LFWA Comments on Site Plan 820200200  
Kensington of Bethesda at Westwood II

August 31, 2020

- **Green Roof Treatment Train:**

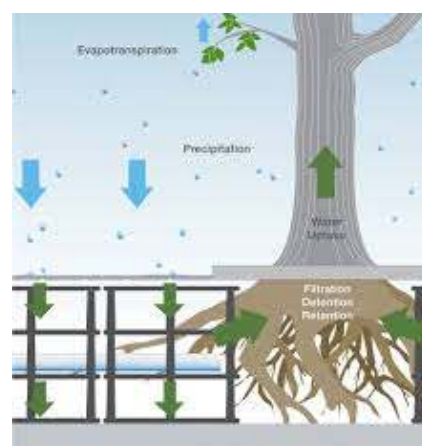
The stormwater management plans calls for 430 square feet of green roof. Although, a green roof is an excellent green technology and good for reducing the heat index and also reducing cooling and heating costs for the building, it does not allow the rain water to infiltrate the ground. However, the run-off from the green roof can be directed to one of the bioretentions. The applicant should be required to incorporate this into the roof drain plans. It doesn't add much to the total volume, but in this site, every little bit is important.
